August 3, 1984

HOPE CREEK GENERATING STATION  
DOCKET NO. 50-354  
DRAFT SAFETY EVALUATION REPORT  
OPEN ITEM STATUS

In addition, enclosed for your review and approval (see Attachment 4) are the resolutions to the Draft SER open items, FSAR question responses and structural geotechnical audit item responses, listed in Attachment 3.

FIGURE A-16-1  
RESPONSE SPECTRA COMPARISON,  
INTAKE STRUCTURE AT ELEV. 93' - 0".

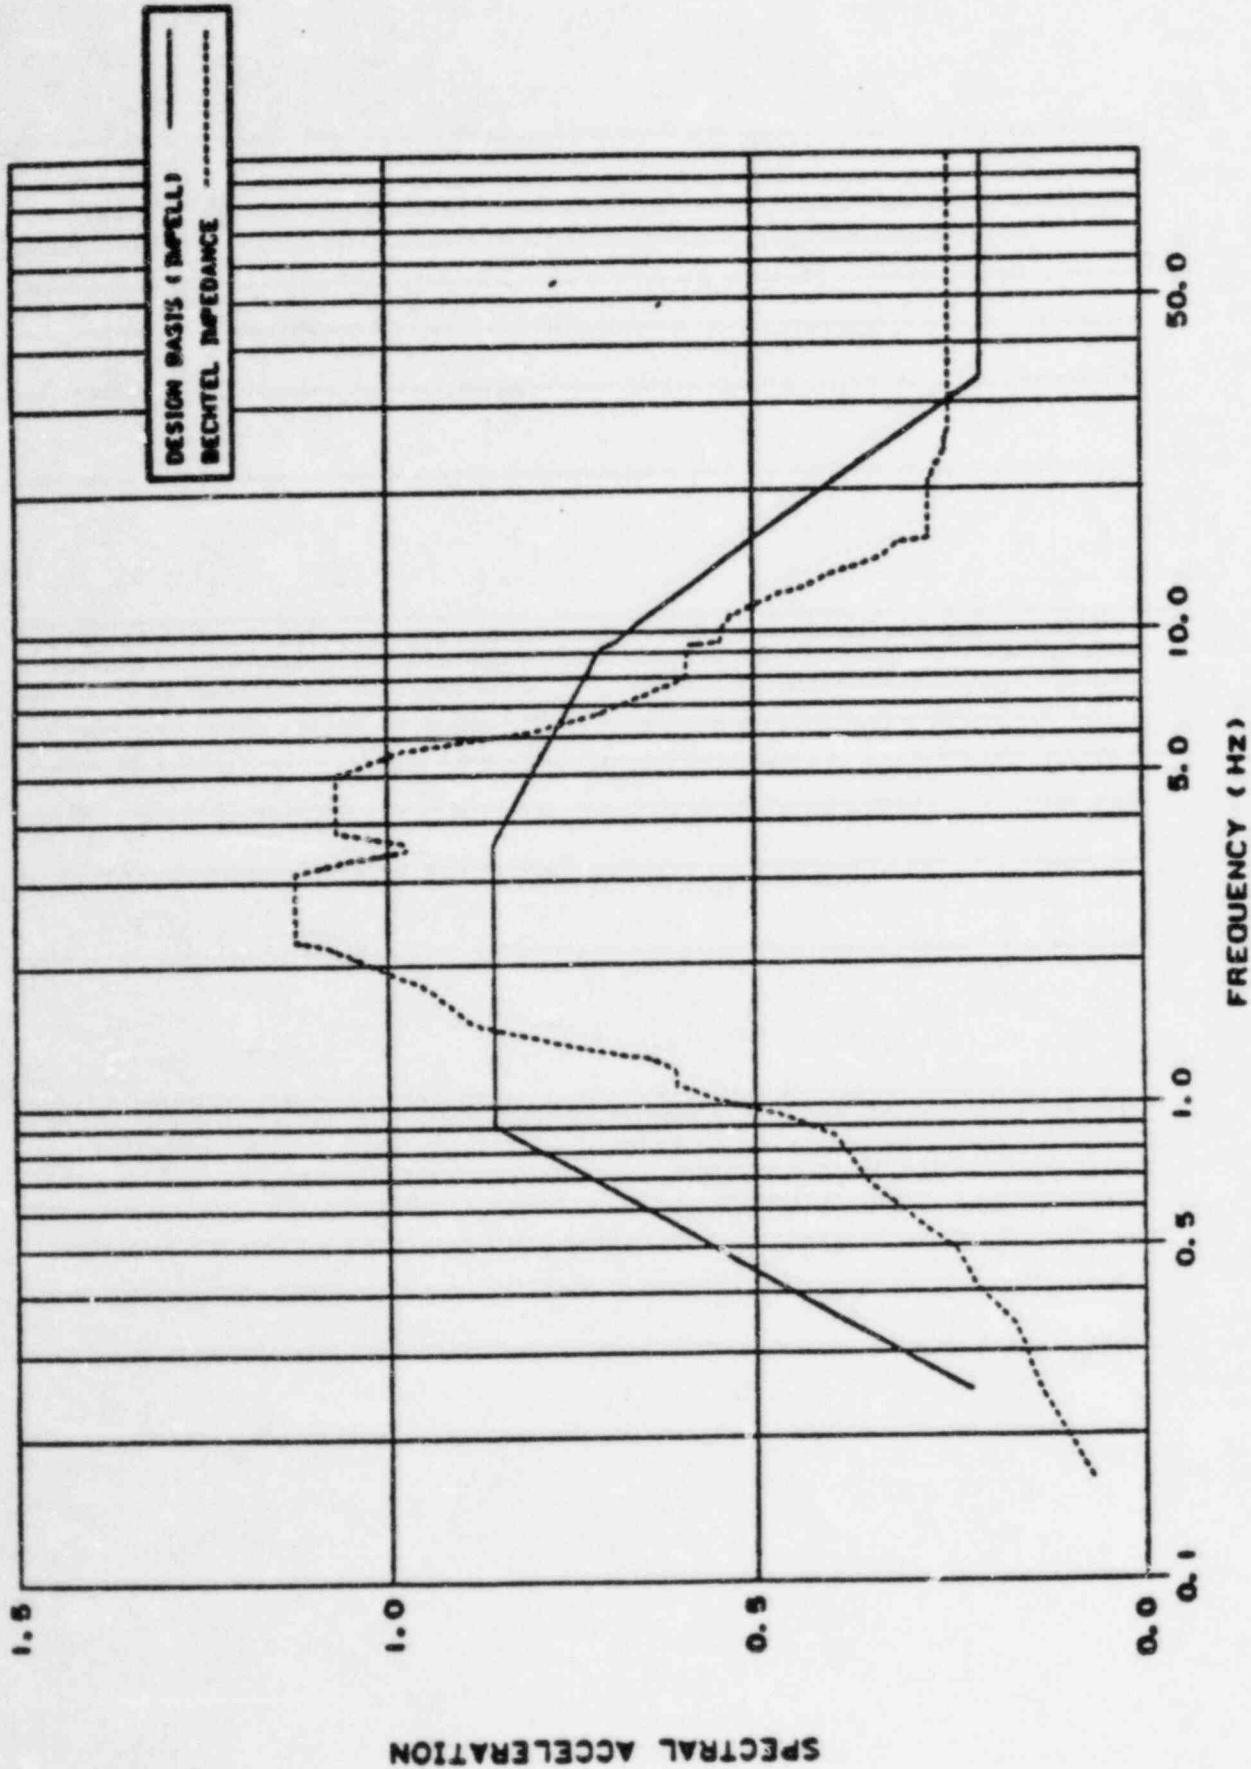
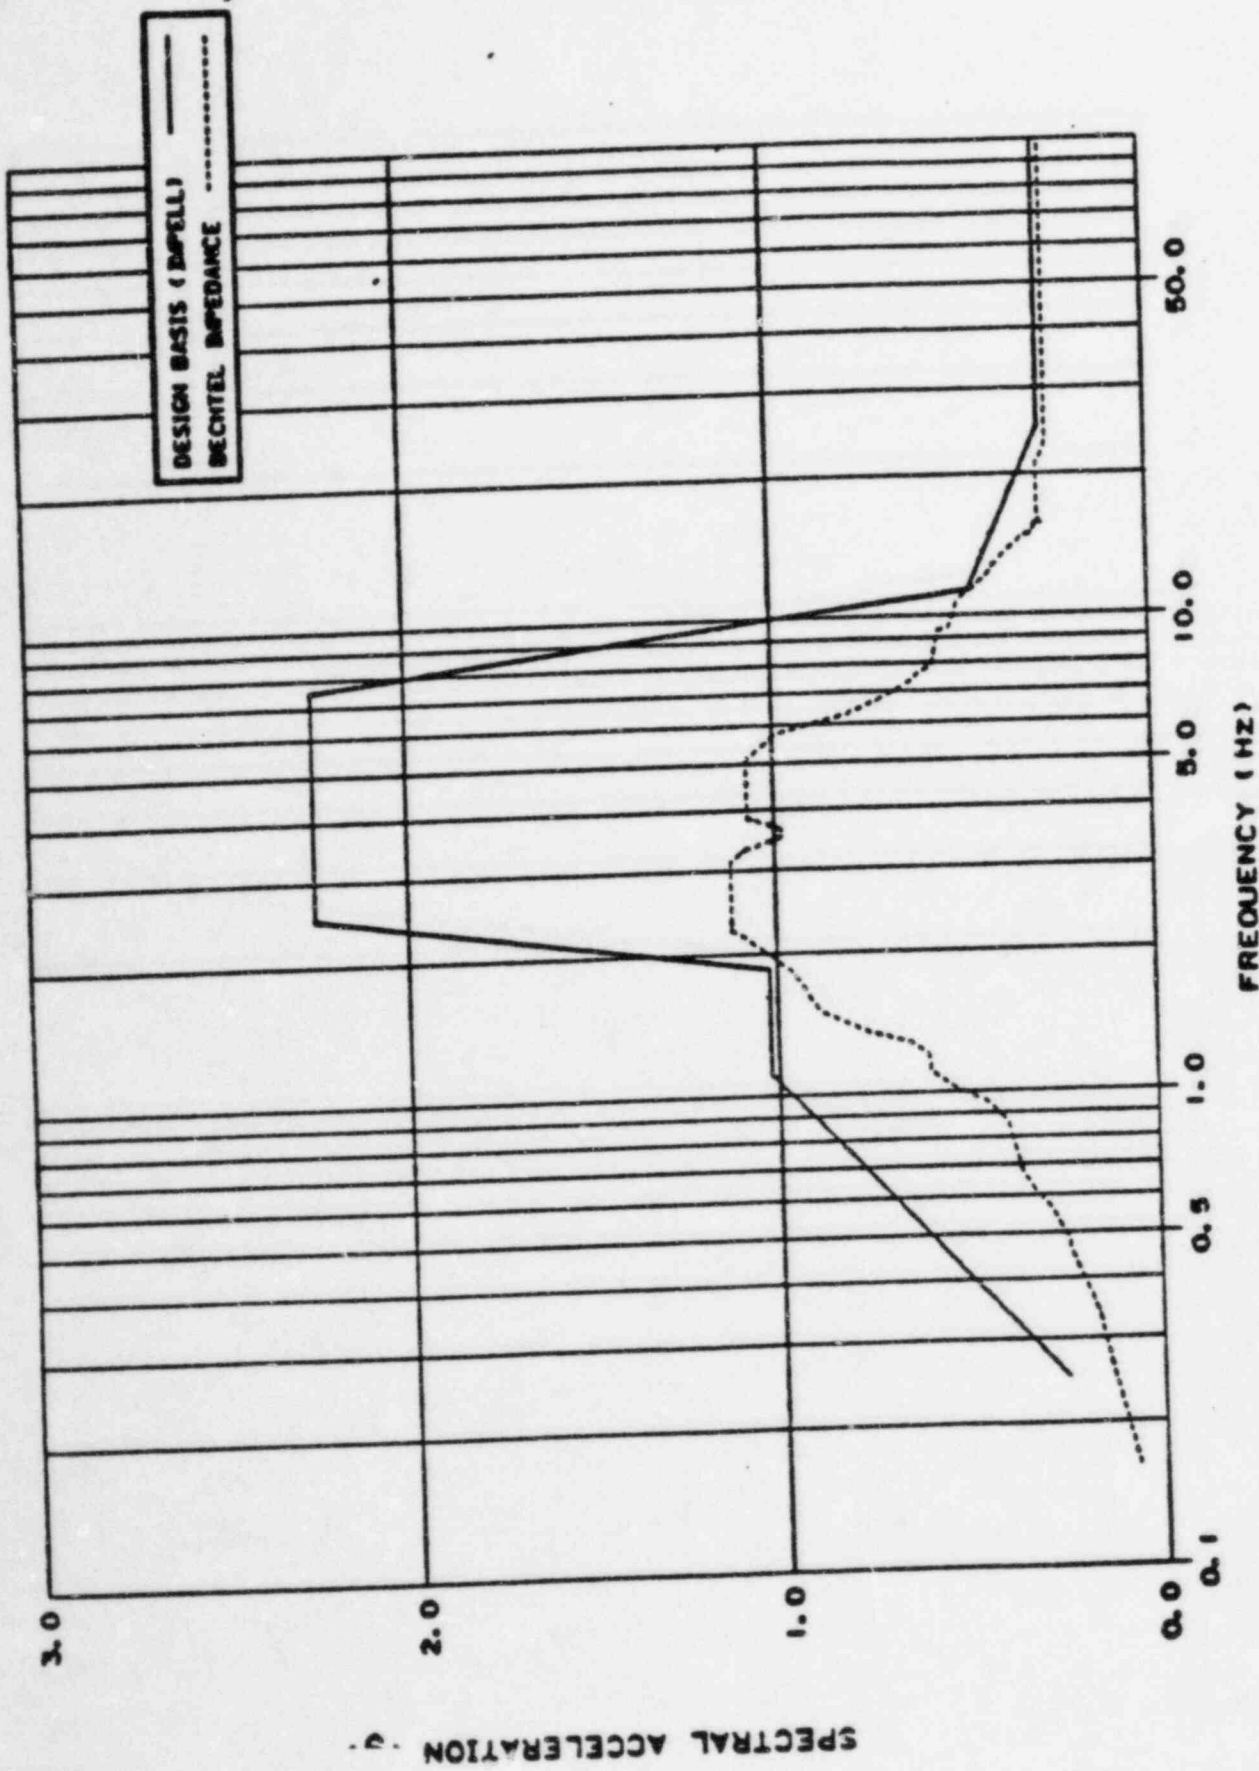
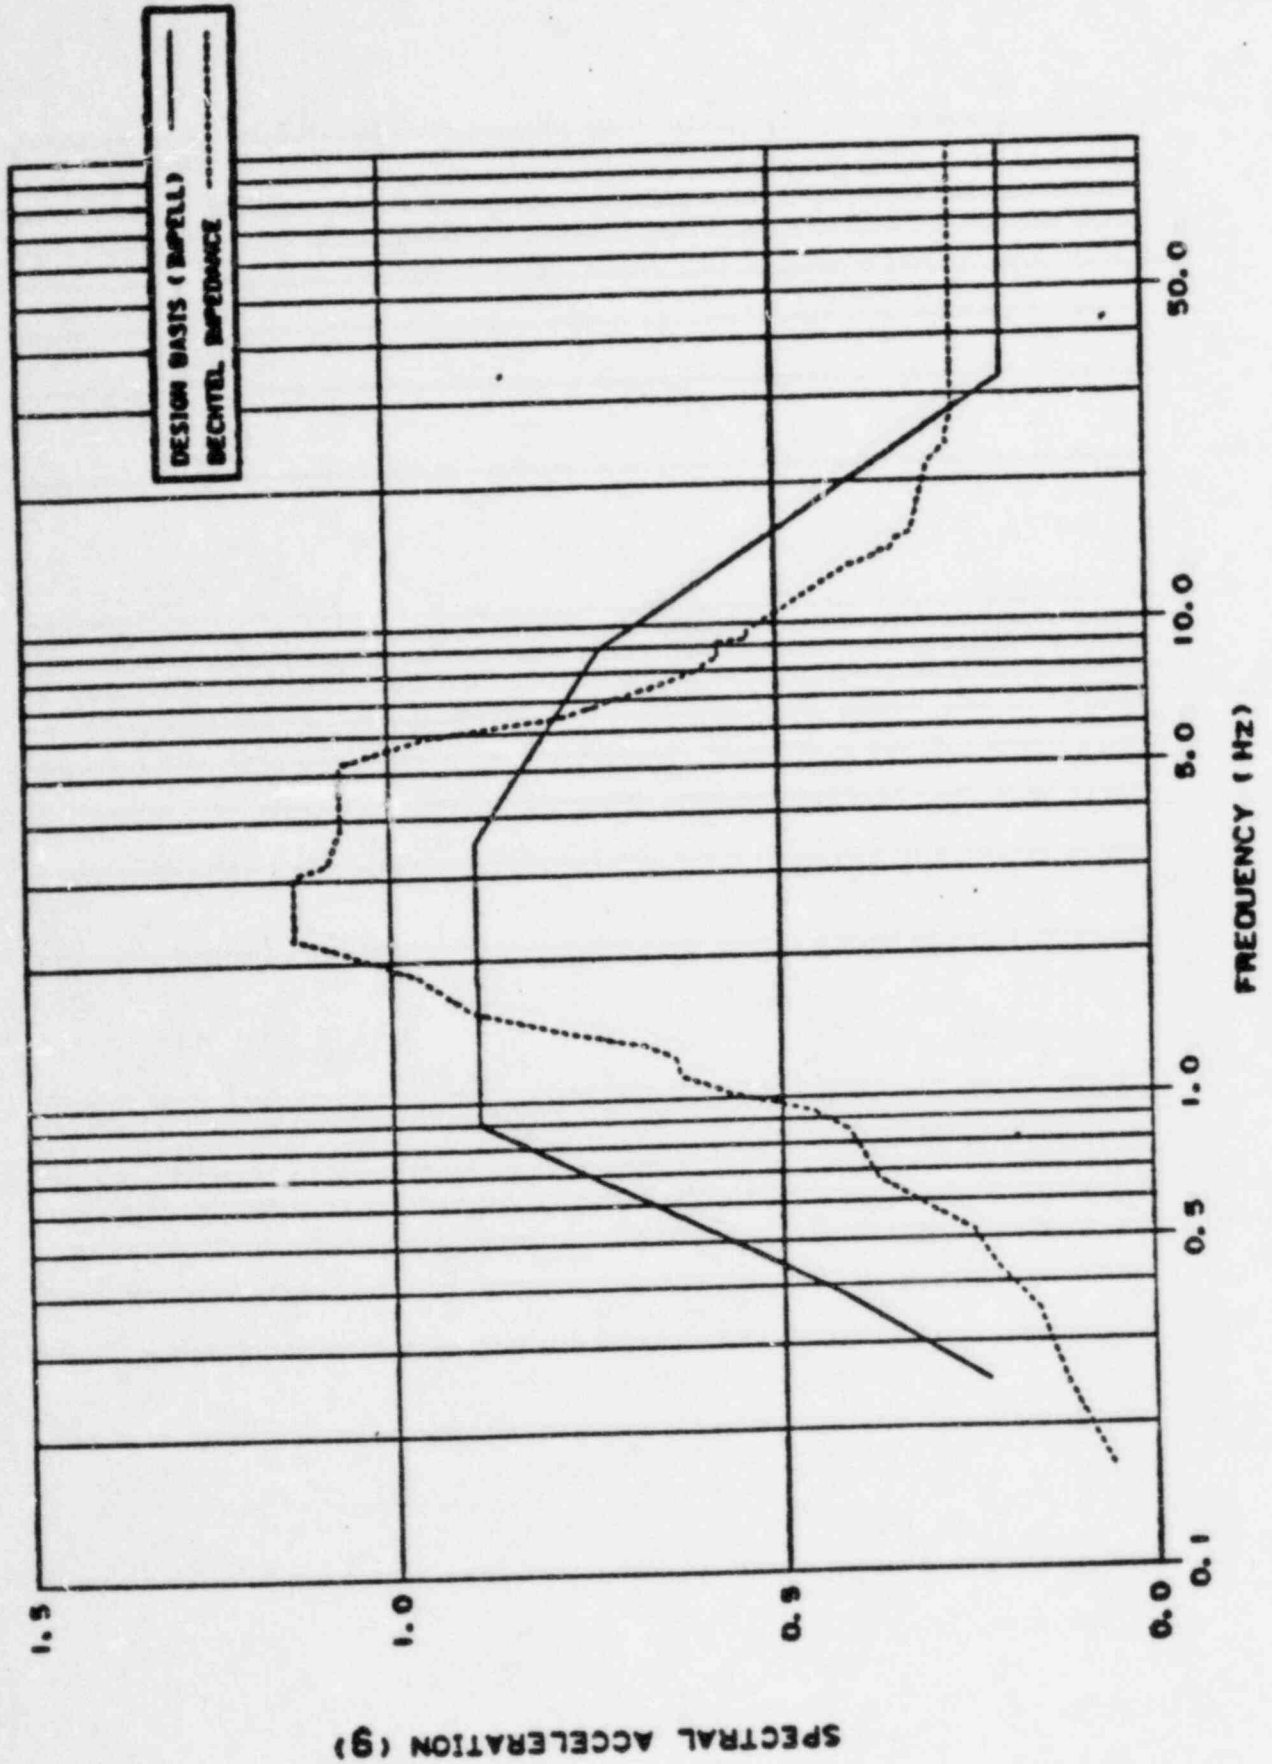
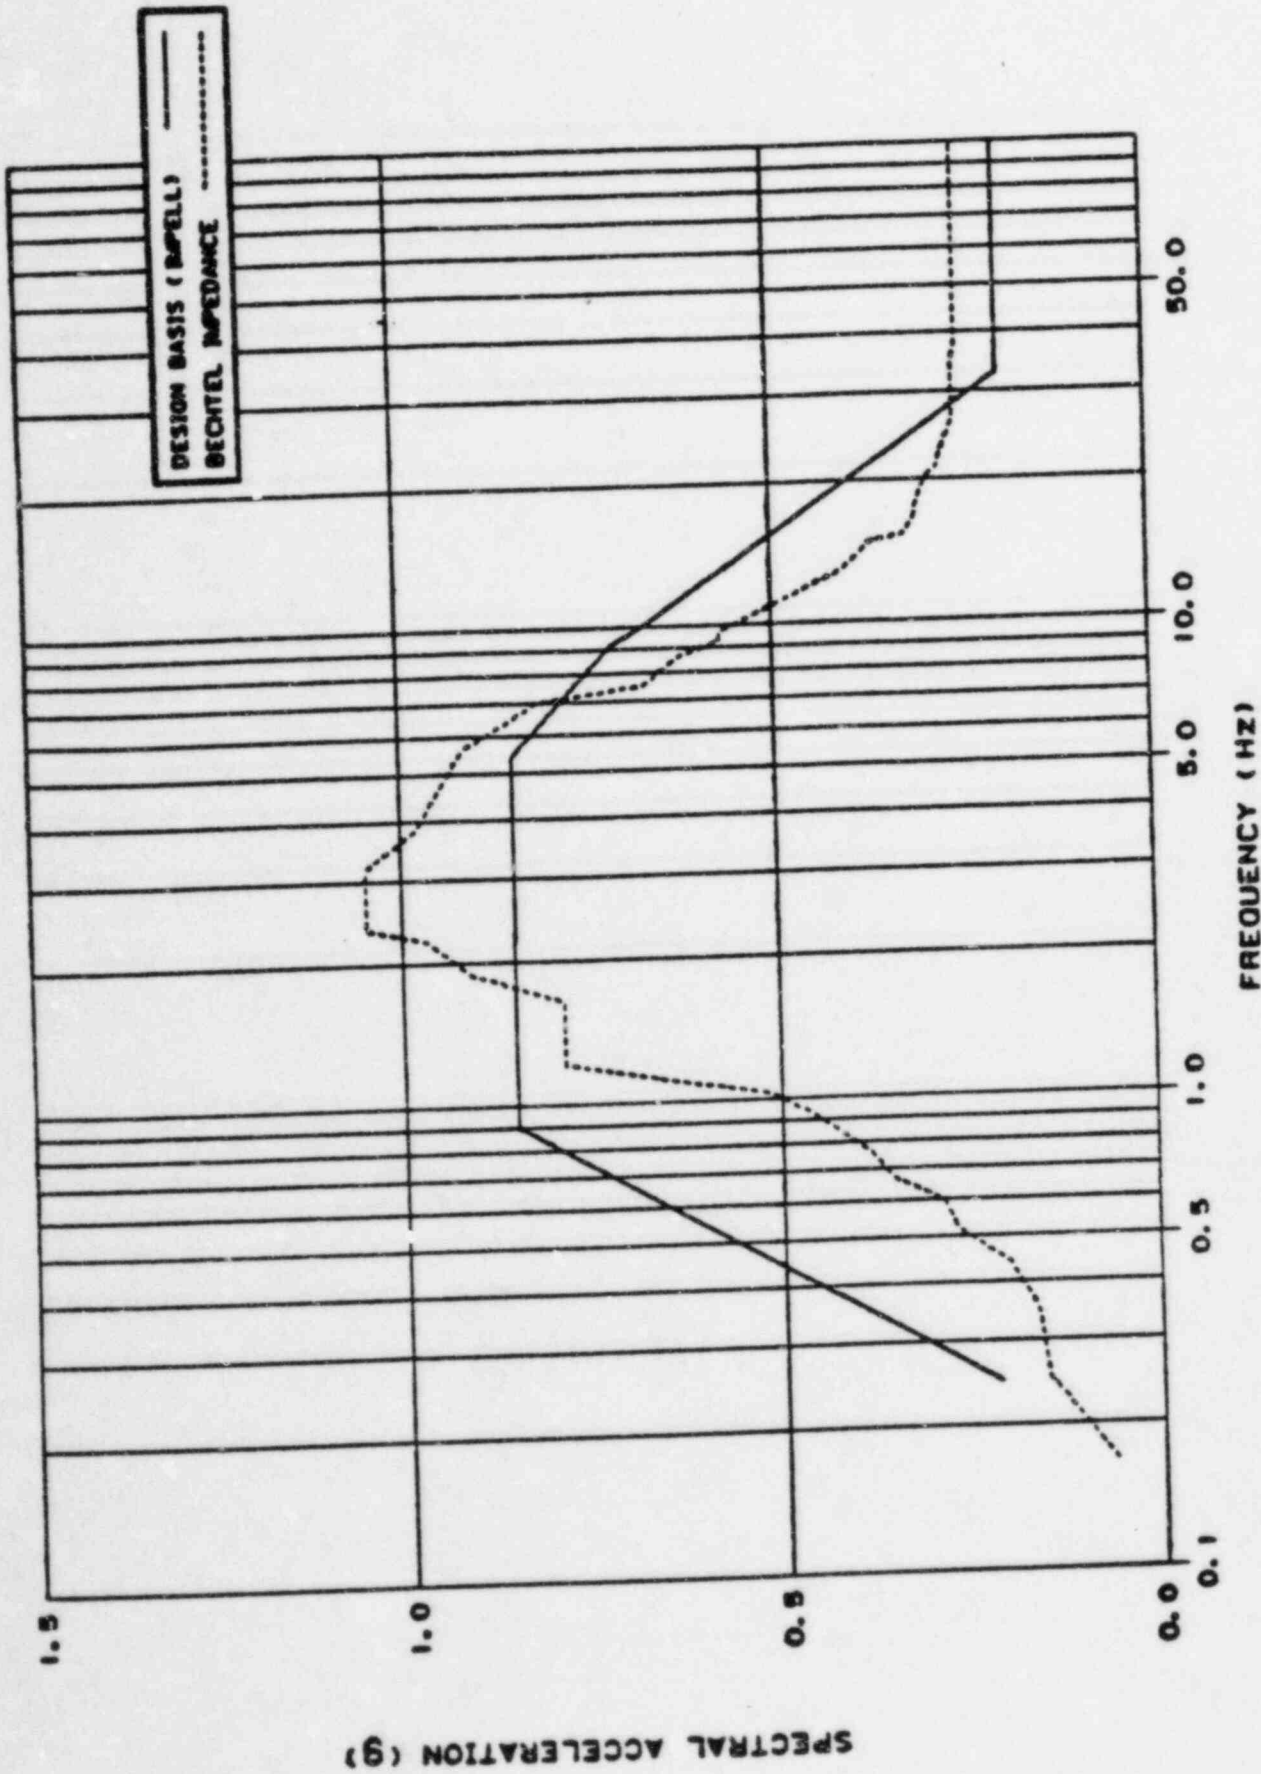
Response

Figures A-16-1 to A-16-18 show the comparison of the 2 percent damping response spectra obtained from the design basis finite element and the impedance approach seismic soil-structure interaction analyses. The impedance approach response spectra generally are enveloped by those obtained from the design basis analyses at elevation 114.0 feet of the SWIS. For other elevations, the impedance approach spectral accelerations exceed the design basis spectral accelerations in some frequency ranges. These ranges vary approximately between 1.5 and 10.0 Hz.
